Our Ref: A15056FMP: JT
Council Ref: PEX2013/0003
RFS REF: LEP/0129 DA15020595664

**Re: Ralston Avenue, Belrose Planning Proposal
Response to the NSW Rural Fire Service (RFS)**

Travers bushfire & ecology (TBE) provide the following response to the issues raised by the NSW Rural Fire Service (RFS) in their letter dated 26th June 2015.

Figure 1 – Slope analysis

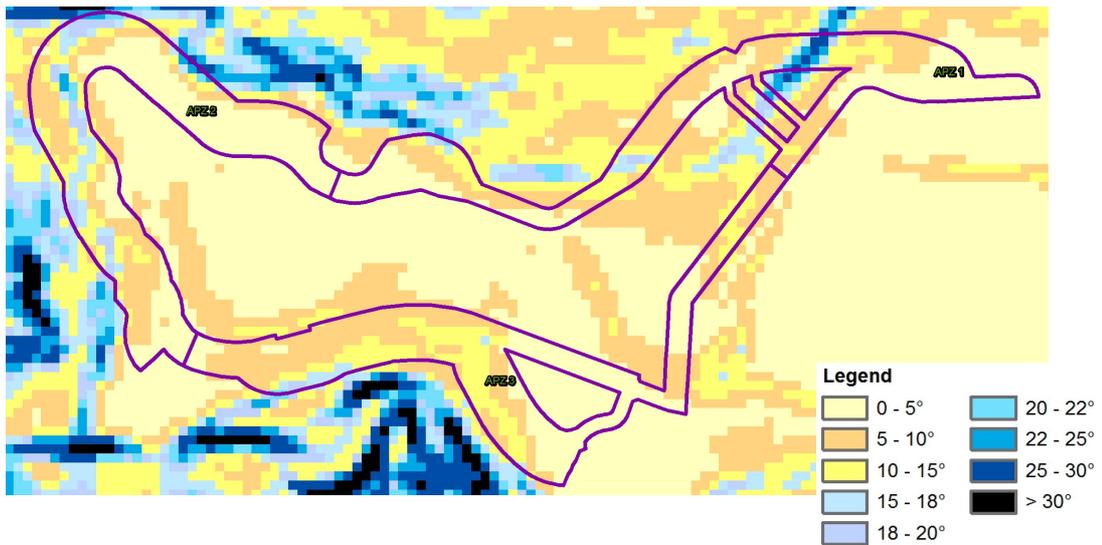
The location of Asset Protection Zones (APZs) on slopes greater than 18 degrees is not supported. The proposal to develop a Fuel Management Plan (FMP) to address the issue of APZs on steep slopes is unsupported.

The following figure (Figure 1) was prepared as part of the FMP and will be used to guide future mechanical works within the APZ. The purple lines depict the full extent of the APZ and includes the APZ which occurs both within the proposed subdivision, road and in the adjoining proposed E3 zone.

Figure 1 was prepared using *LiDAR* data equivalent to 1.0m contours. As depicted in Figure 1 the majority of the APZ support slopes less than 18 degrees. The small sections of APZ depicted in dark blue in the north-east, and even smaller section in the north-west, have a slope greater than 25 degrees. These small areas represent rock face / ledges, typically devoid of fuel and would require minimum APZ maintenance and virtually no removal of trees to accord with the RFS 2m separation of tree canopies. Rocky escarpments can have the effect of reducing the bushfire risk posed to a site and act, in effect, as a radiant heat barrier. In light of the above, and as determined during the preparation of the bushfire protection assessment, the small sections of land within the APZ comply with Section 4.1.3 of *Planning for Bush Fire Protection (PBP)*.

The APZ was determined based on Table 2.4.2 of AS3959 which identifies an APZ of 61m adjacent to forest vegetation on slopes of >15–20 degrees. Although AS3959 does not recognise APZ setbacks for hazardous vegetation on slopes greater than 20° the graphic slope analysis shown on Figure 1 and Figure 3 displays the true slopes gradients and the RFS concern should now be resolved.

Figure 2 – APZ apportionment

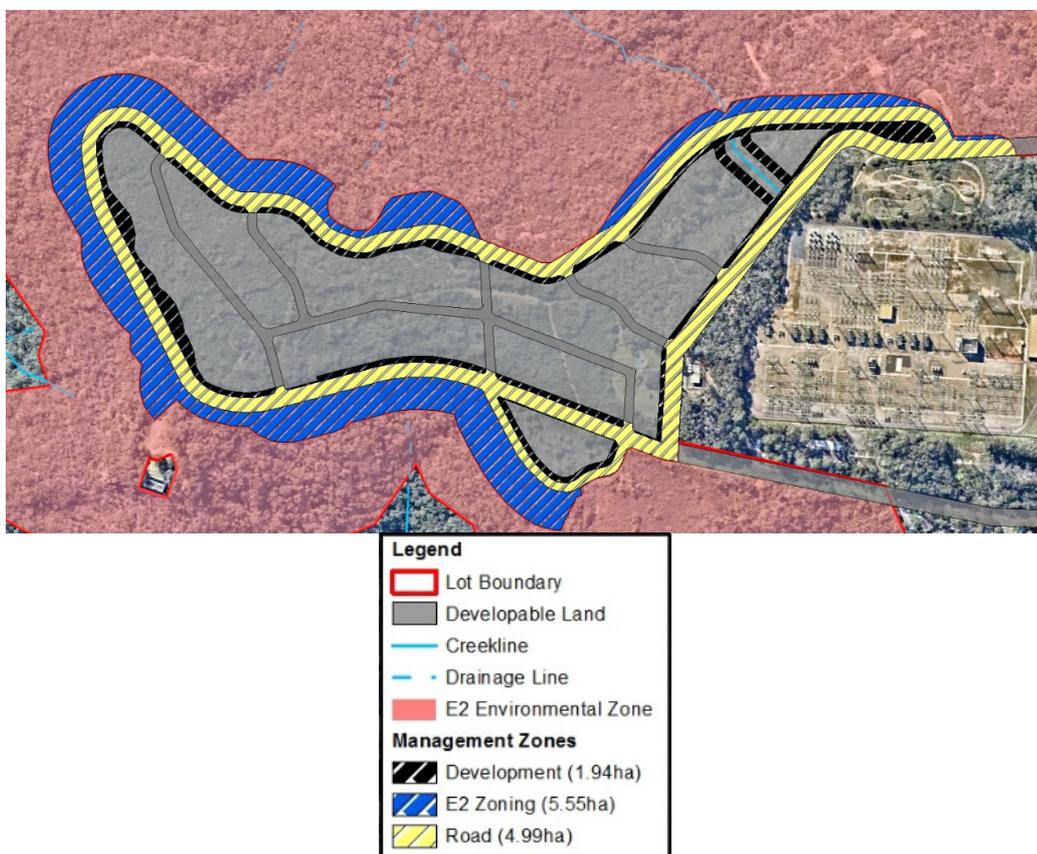
The APZs are proposed to be located on land which is to be rezoned E2 Environmental Conservation which may conflict with the objectives of the zone given the extent of area to be managed.

Figure 2 depicts the breakup of the lands that occurs within the APZ i.e. the portion of the dwelling allotment, the portion that occurs within the public roadway and the portion that occurs within the E3 lands. The area in hectares for each portion is provided in the legend.

Figure 2 depicts the extent of the APZ in the E3 zone. This figure illustrates that the hazardous landscape to be managed equates to 5.54ha. This being the land that does not contain the portion of the public road and / or the setbacks within the private allotments. The remaining portion of the APZ consists of public road (4.99ha) and areas within each allotment (1.94ha).

Figure 3 – Slope gradient depiction of slopes between 21-33 degrees and over 33 degrees

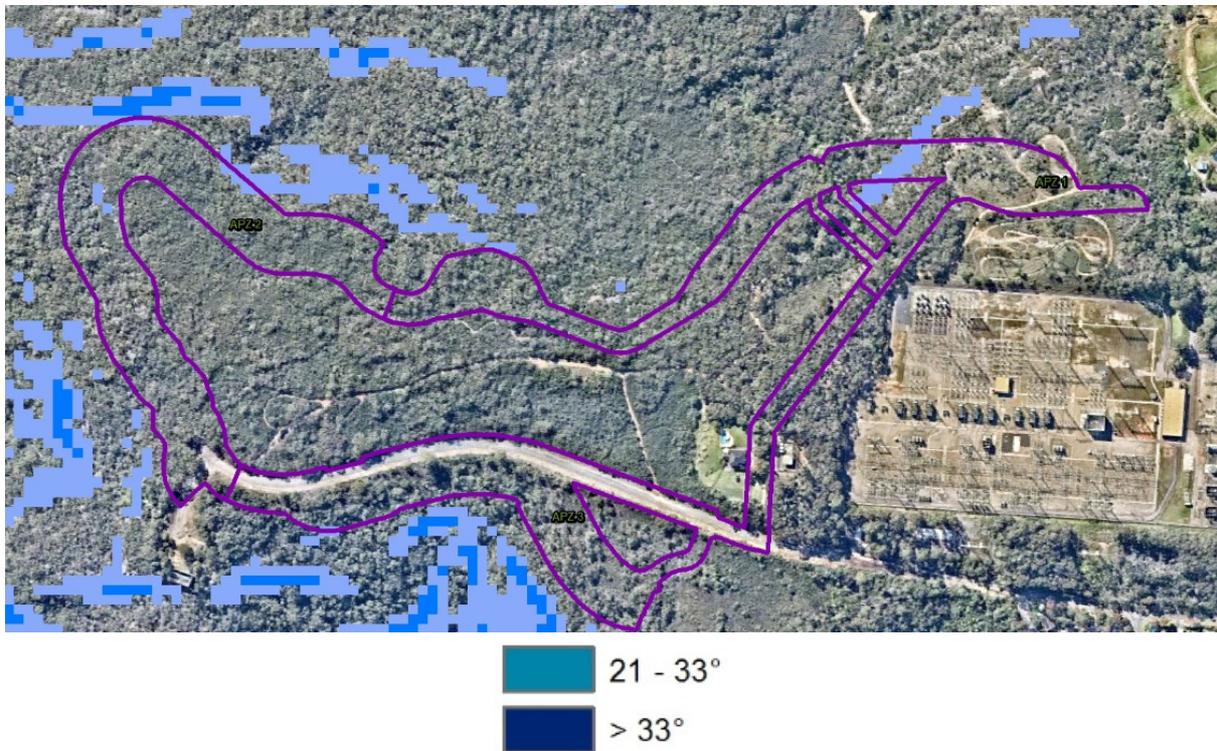
- ***An additional 1 metre APZ where slopes exceeded 18 degrees. The additional 1 metre APZ is considered inconsequential to compensate for the additional increase in slope.***

The RFS has long taken the view that slopes over 18 degrees are acceptable when they are comprised of stable surfaces such as rock. This is the case over parts of the development site and our explanatory graphics herein advise the area of steep lands greater than 20 degrees is limited – see Figure 3.

Figure 3 illustrates the slope gradients even further by eliminating the slopes below 20 degrees and retaining the slopes between 21-33 degrees; and slopes over 33 degrees. This graphic displays the very small zone of slope between 21-33 degrees as a narrow vestige in the north-east of the APZ. Similarly, the graphic shows that there are very small areas of slopes greater than 33 degrees occurring external to the APZ.

Figure 4 – Management zones

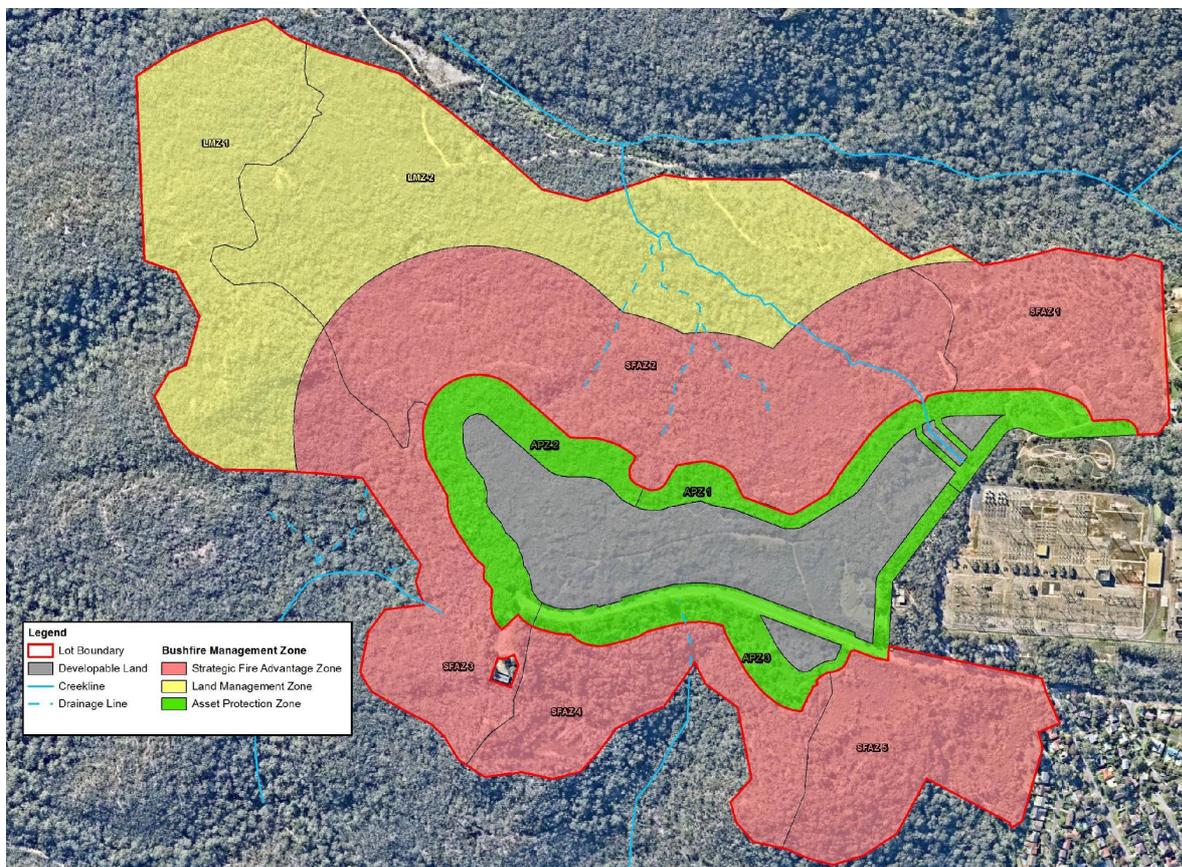
- ***A 100m Strategic Fire Advantage Zone (SFAZ) around the periphery of the site. It is assumed this means the perimeter of the R2 Low Density Residential zoned land. The ongoing management of the SFAZ is expected to fall to the NSW RFS creating an additional burden on existing resources.***

- **The management of the APZ within the SFAZ is likely to be problematic in terms of defining the boundaries of each zone. APZs cannot be located within an SFAZ as APZs are usually maintained by mechanical means and SFAZs by prescribed burning. Mechanical works are not permitted in a SFAZ.**

As detailed within the FMP (refer Figure 4 below), the SFAZ is measured from the periphery of the APZ. Ecological management (i.e. burning) will be undertaken in accordance with the FMP by the *MLALC*.

As detailed within the FMP (refer Figure 3), the SFAZ is measured from the periphery of the APZ.
